RE: Drainage Report and Grading and Drainage Plan for Vineyard Estates Unit IIIA (C20/D3D) Submitted for Preliminary and Final Plat Approval, Grading Permit, and Work Order Approval, Engineer's Stamp Dated 1/18/99.

VINEYARD ESTATES UNIT IIIA

RE: *Drainage Report and Grading and Drainage Plan for Vineyard Estates Unit IIIA (C20/D3D) Submitted for Final Plat Approval, Engineer's Stamp Dated 3/8/99.*

**RE: *Grading and Drainage Certification Plan for Vineyard Estates Unit IIIA (C20/D3D)
Submitted for Release of Financial Guarantees, Engineer's Certification Stamp Dated
11/4/99.***

OFFSITE BASIN MAP, UNIT HYDROGRAPH, DRAINAGE CALCULATIONS
VINEYARD ESTATES, UNIT III A

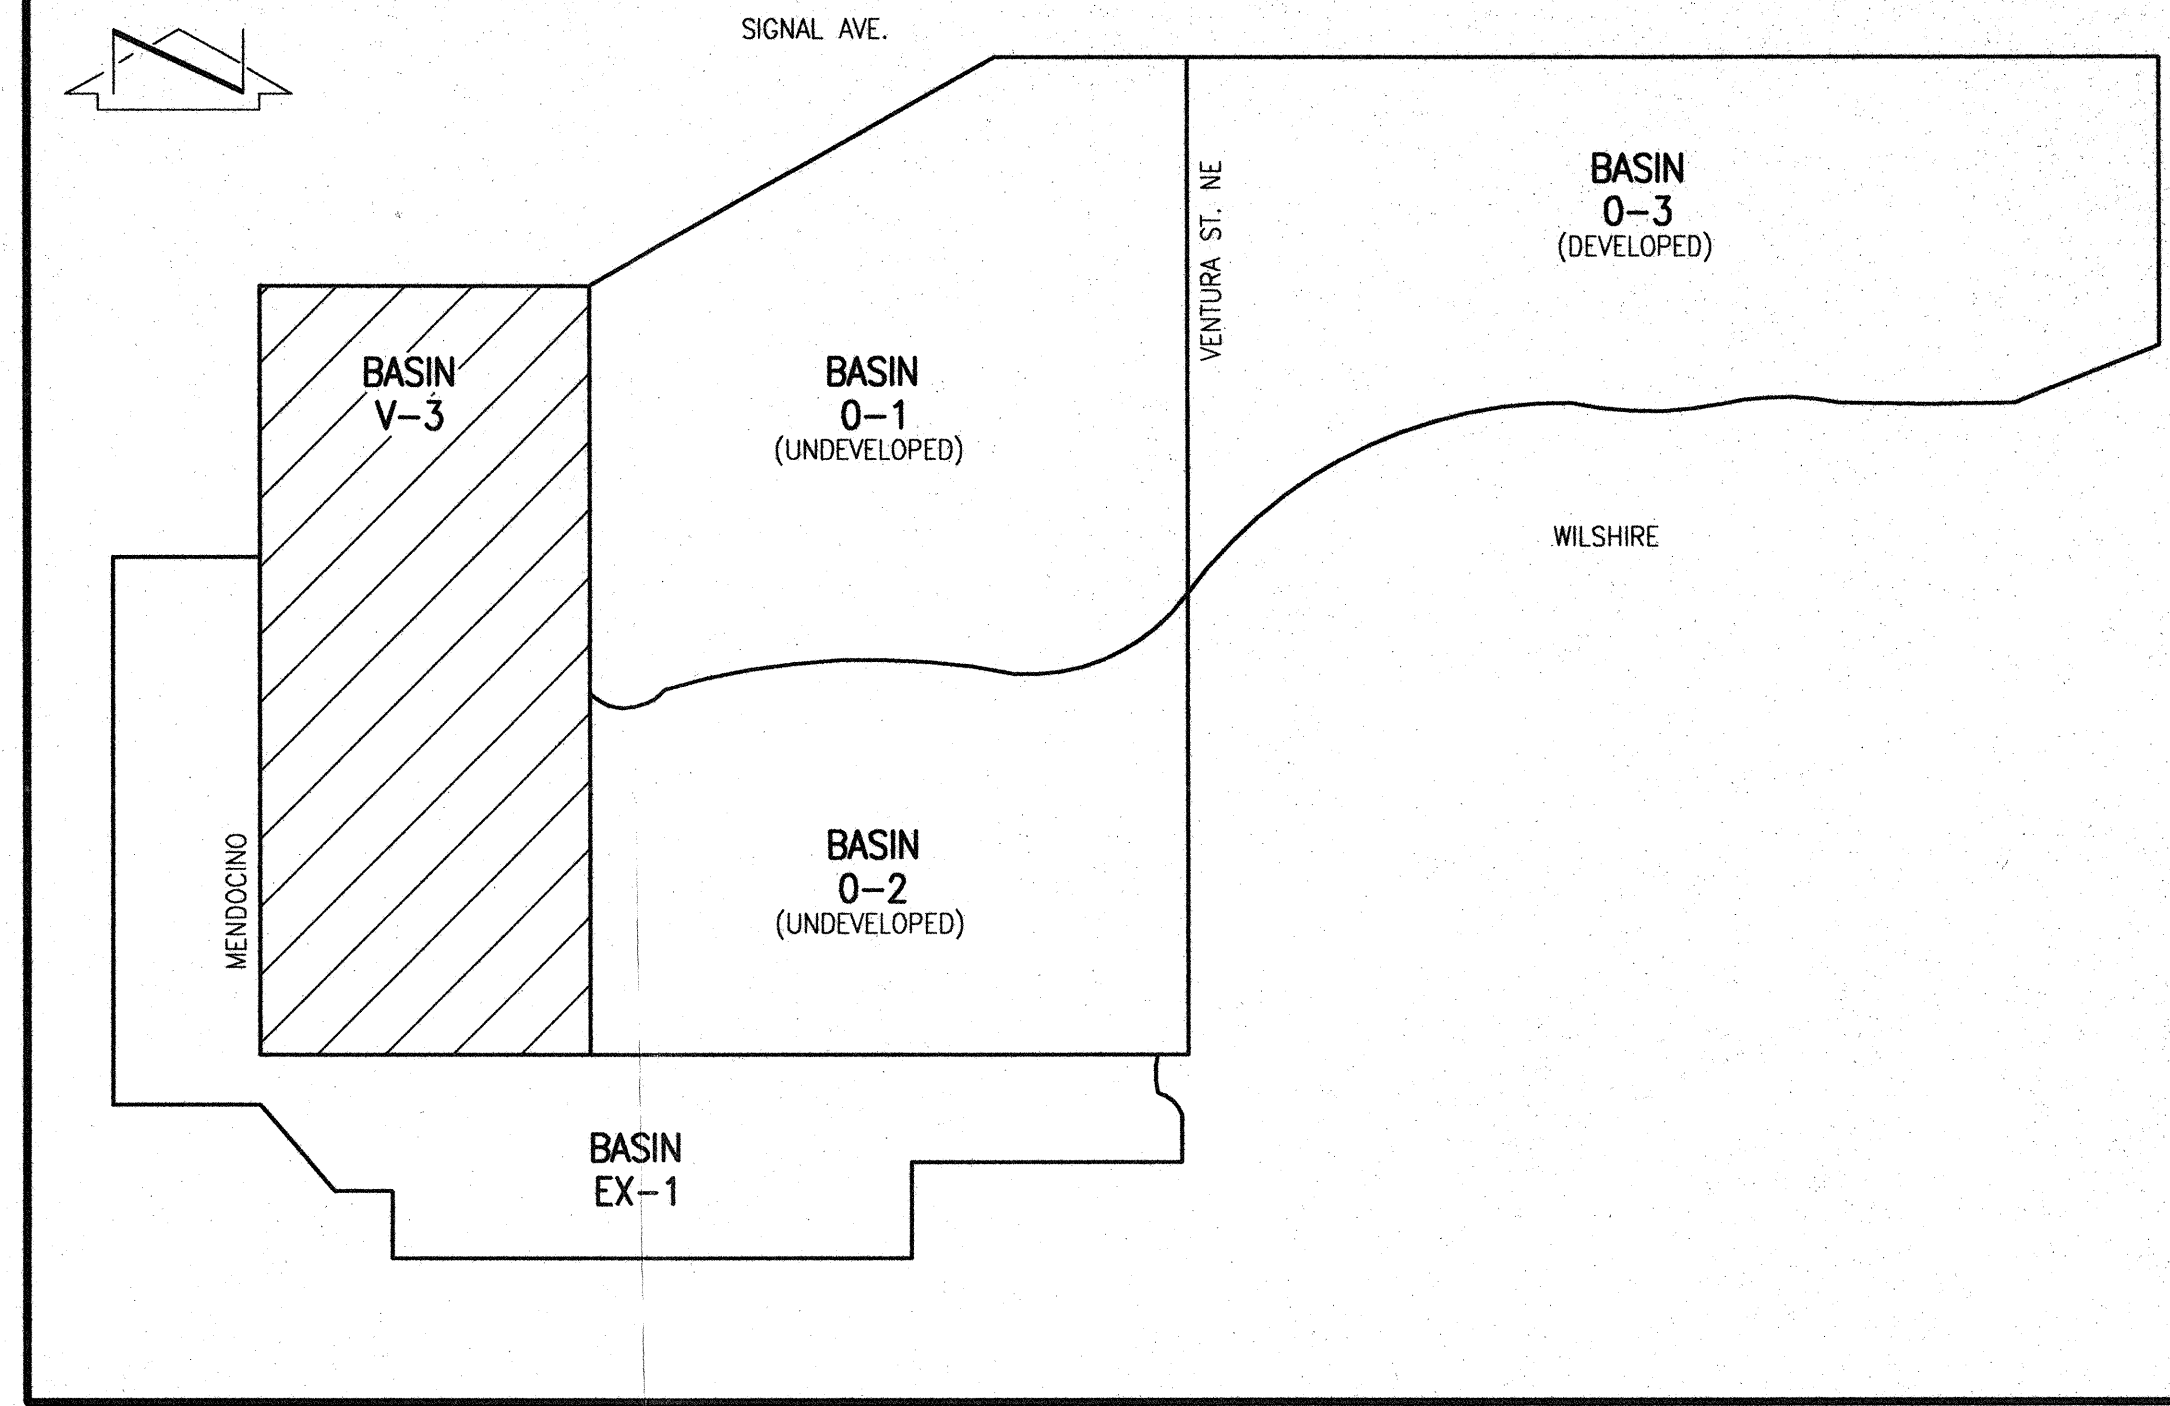
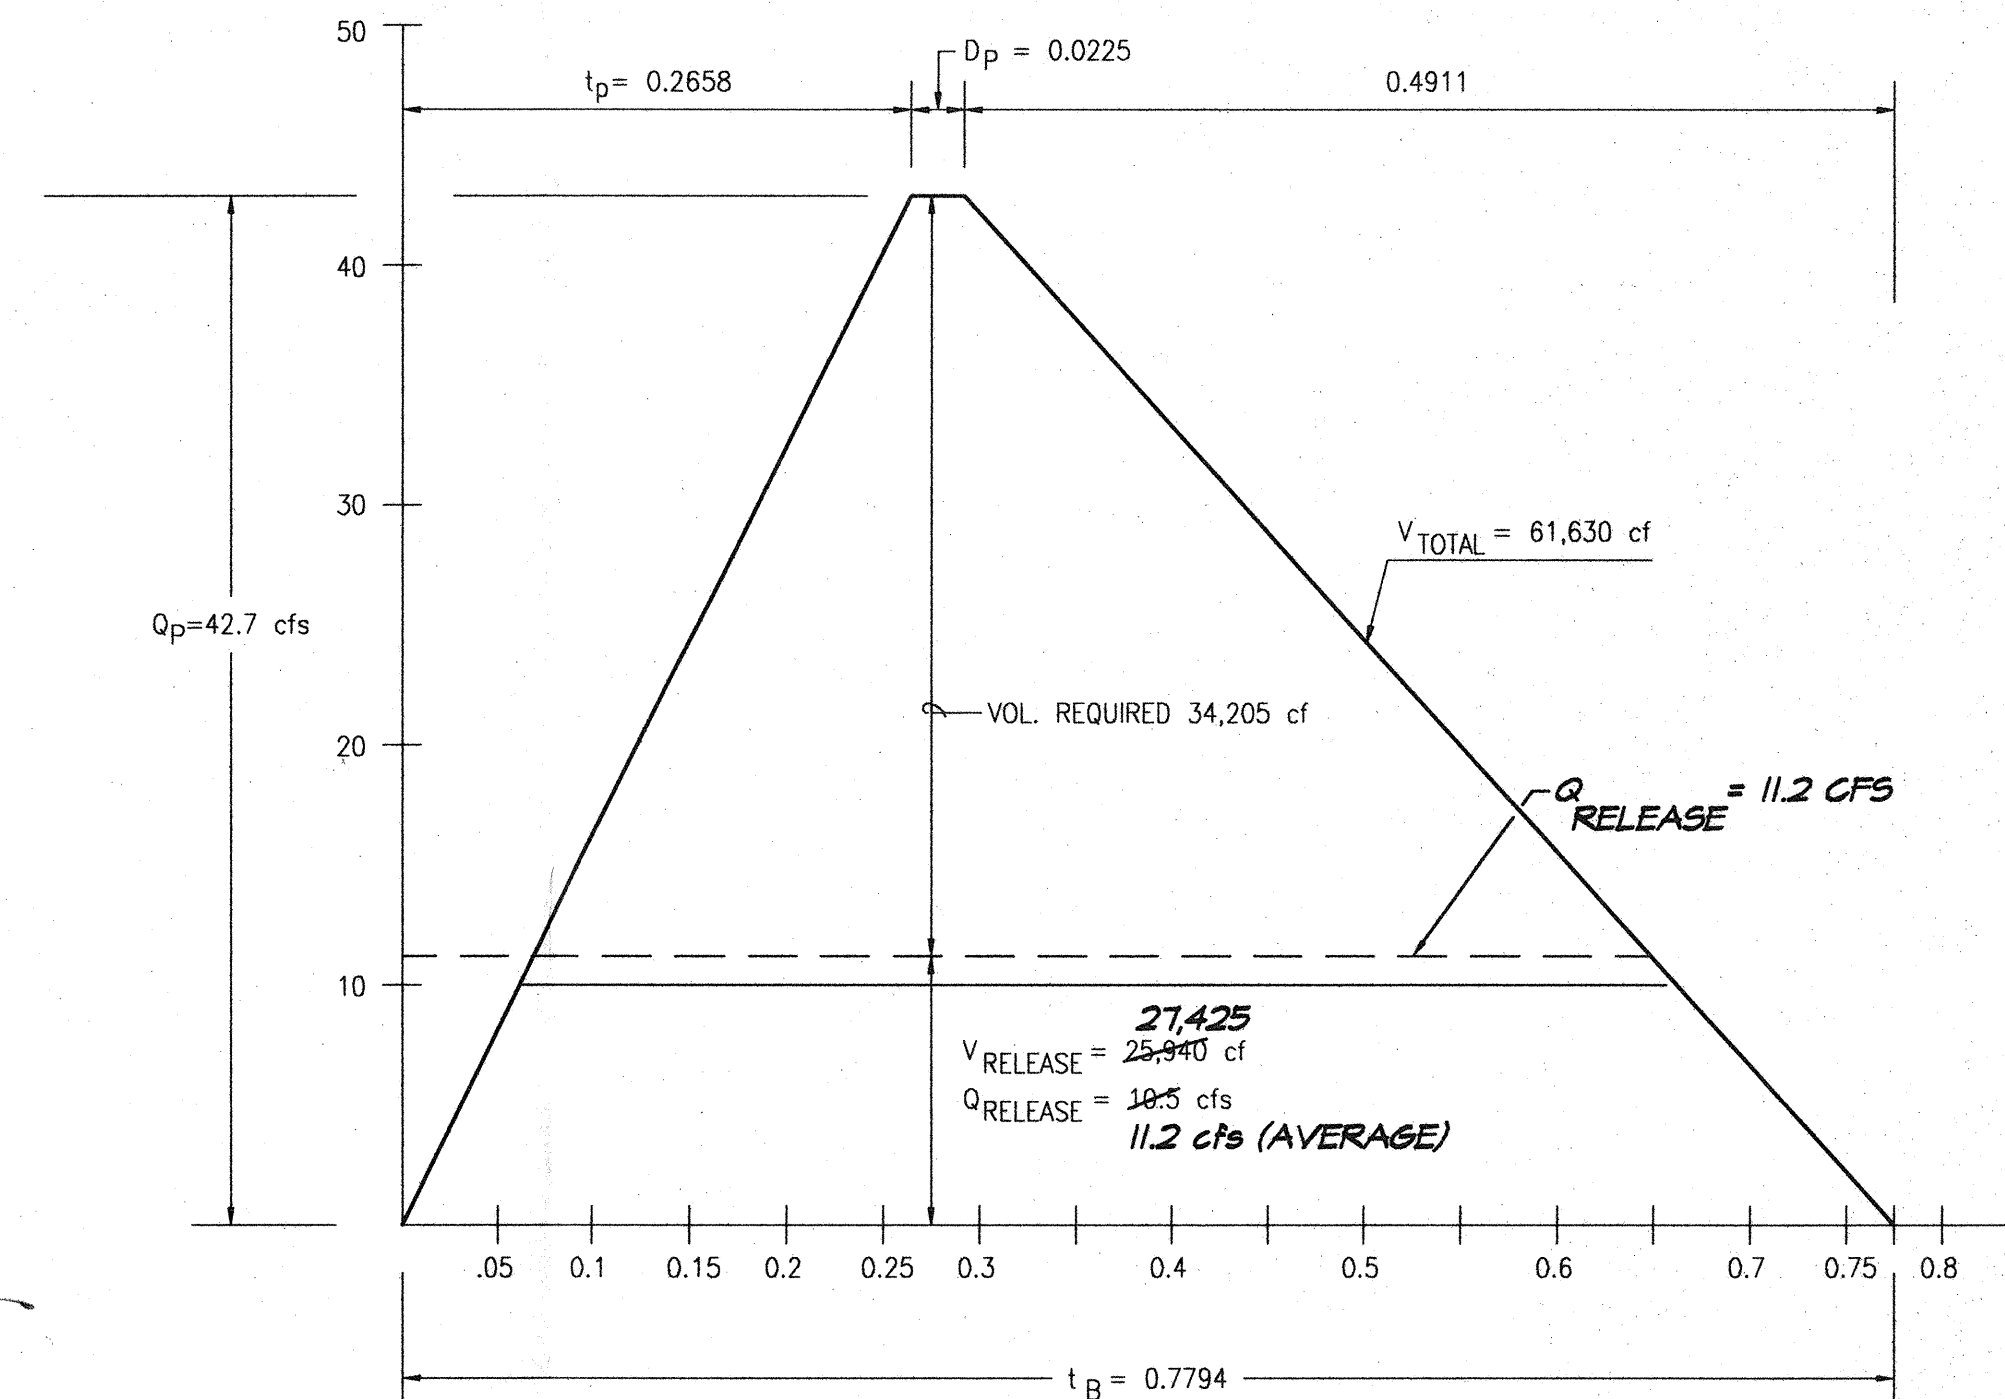
Basin?
0-1?

Basin ?
03-

Basin ?
02-

*developed
flows
to the
front*
